UC Santa Cruz
Marine Science Campus CLRDP
Environmental Impact Report
(SCH No. 2001112014)
Addendum #1:
Proposed Revisions to the CLRDP

November 2006

Prepared by: Martin Carver, AICP
Coastplans
244 Plateau Avenue
Santa Cruz, California 95060

Fig. 5.2 Land Use Diagram

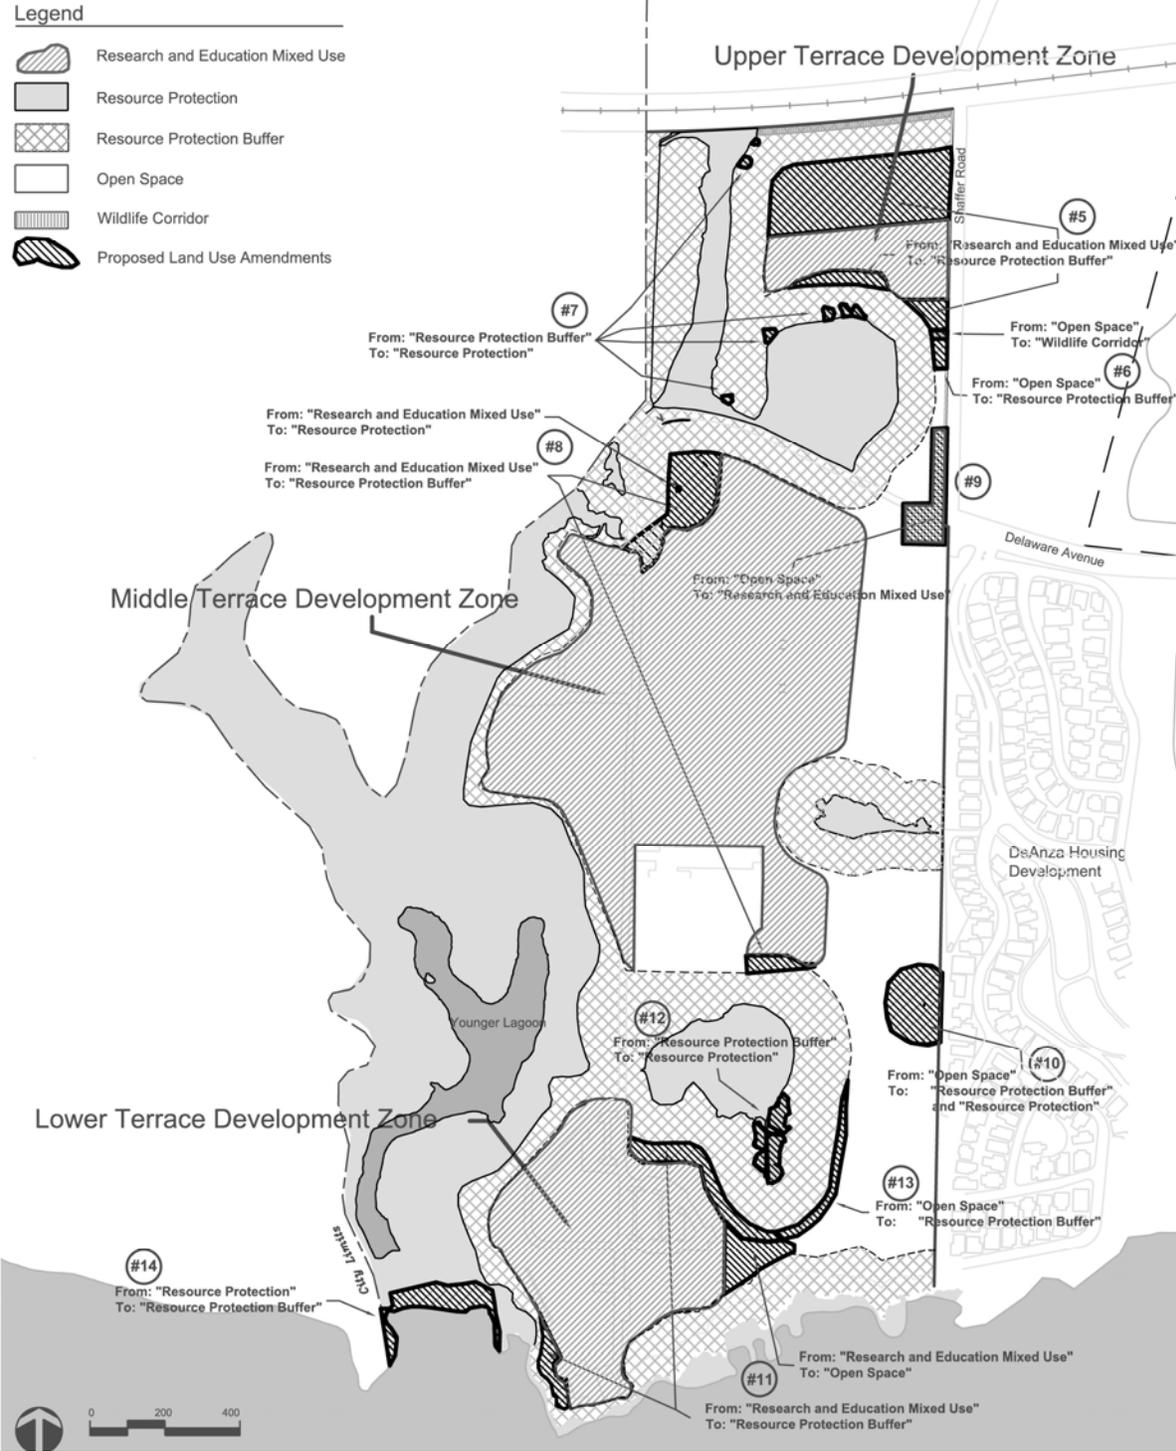
The following proposed minor CLRDP amendments are proposed (see CLRDP Figure 5.2, Land Use Diagram, below in Section 3.4):

Table 1 summarizes minor amendments to CLRDP Figure 5.2, Land Use Diagram.

None of these minor amendments constitutes a substantial change in CLRDP principle or policy. The proposed amendments to CLRDP Figure 5.2, Land Use Diagram, would result in the redesignation of 6.22 acres of campus land. Changes to the three existing CLRDP *development zones* (i.e., Upper, Middle, and Lower Terrace), however, involve only 3.96 acres of redesignated land. While the redesignation of this land reduces developable area, the redesignated land would not be essential to achieving full implementation of the CLRDP program. The net effect of the proposed amendments would be to reduce the flexibility otherwise available in the land use plan to achieve the objectives of the CLRDP. The full building program is still achievable (albeit without the 80 units of support housing), but there are fewer choices as to where research and education uses can be located.

Fig. 5.3 Locational Restrictions for Building Program

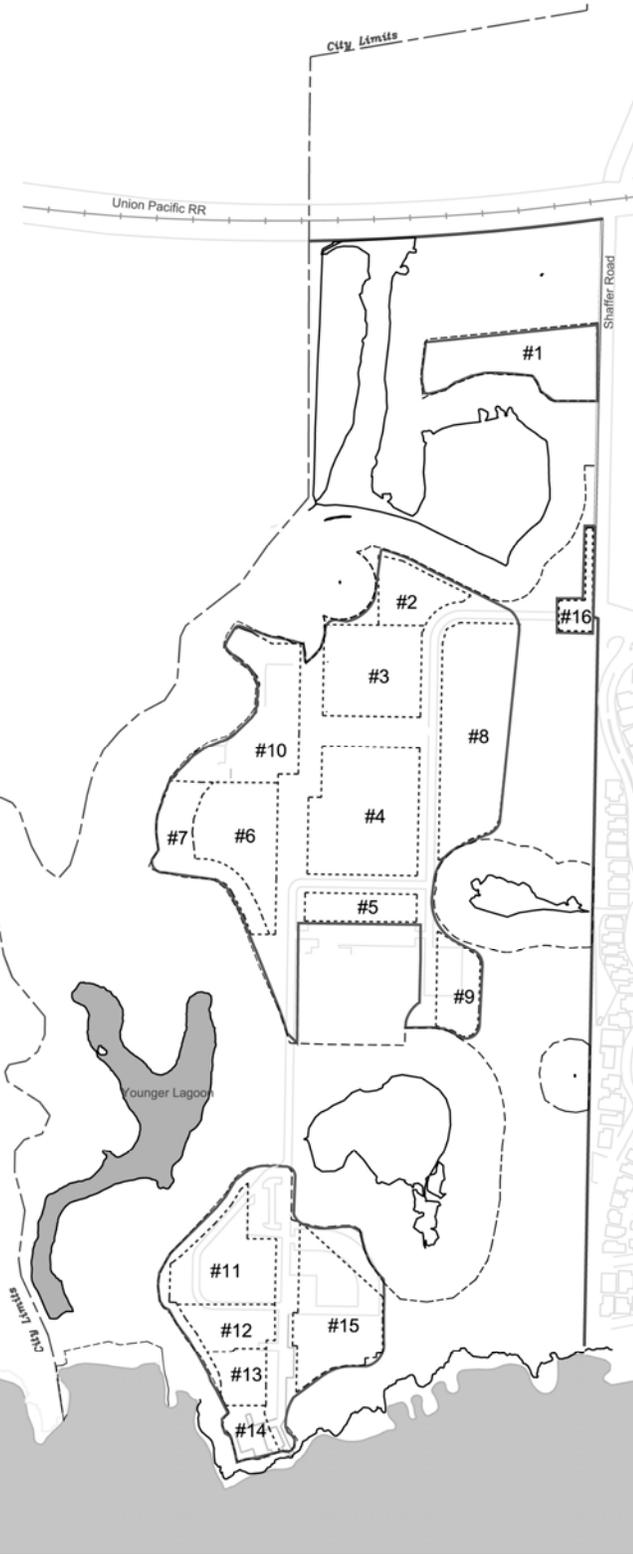
17. Revised Location Restrictions: Revision of locational restrictions on researcher accommodations (see CLRDP Figure 5.3, Locational Restrictions, in Section 3.4 below) to allow the option of clustering 30 rooms of researcher housing in one area within the Middle Terrace development zone, in addition to the existing option of dispersing units throughout the Middle Terrace development zone.¹⁵

Proposed Revisions
Fig. 7.2 Illustrative
Campus Buildout Site Plan

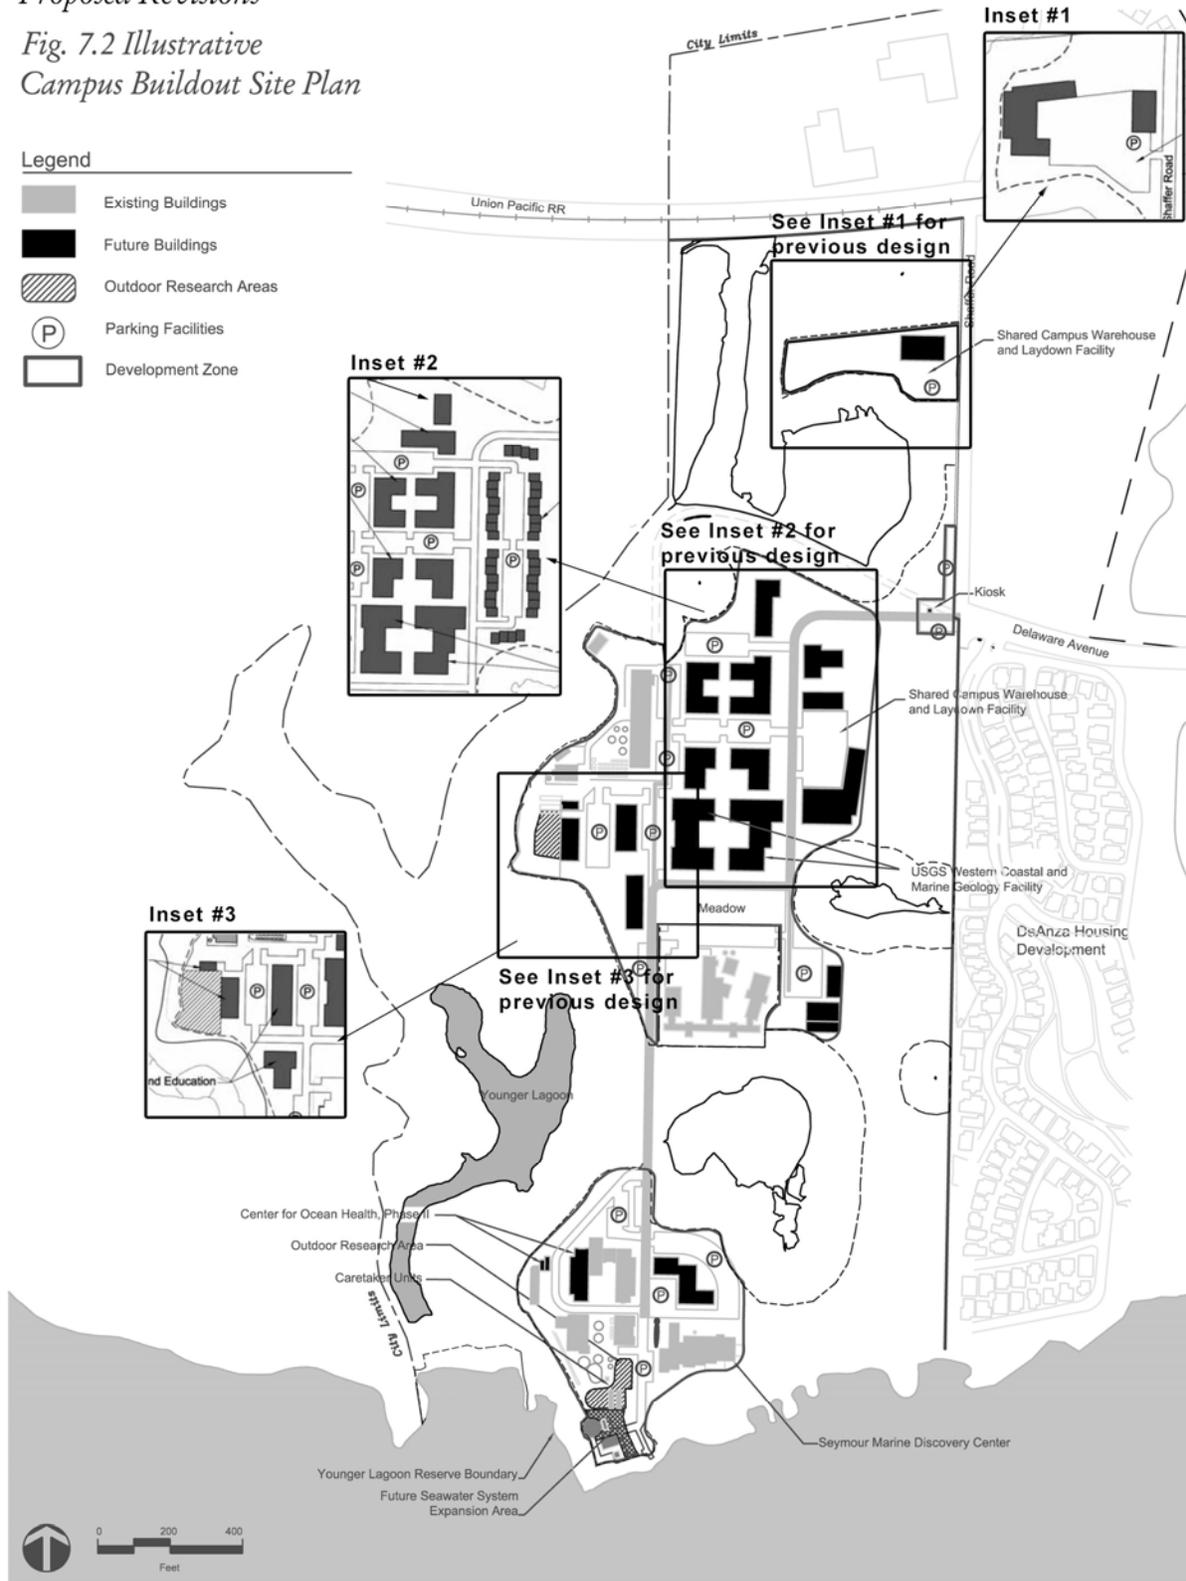
20. SORACC Eliminated: Elimination of the Sea Otter Research and Conservation Center (SORACC) as a near-term project. UCSC no longer anticipates development of this specific project as described in CLRDP Chapter 7 (see revised CLRDP Figure 7.2, Illustrative Campus Buildout Site Plan, in Section 3.4 below). The 10,000 square feet of building space associated with this project would be included in the overall CLRDP building program for education and research development consistent with CLRDP guidelines and land uses. Any future development proposal would be subject to all the policies, implementation measures, and design guidelines of the CLRDP.¹⁷
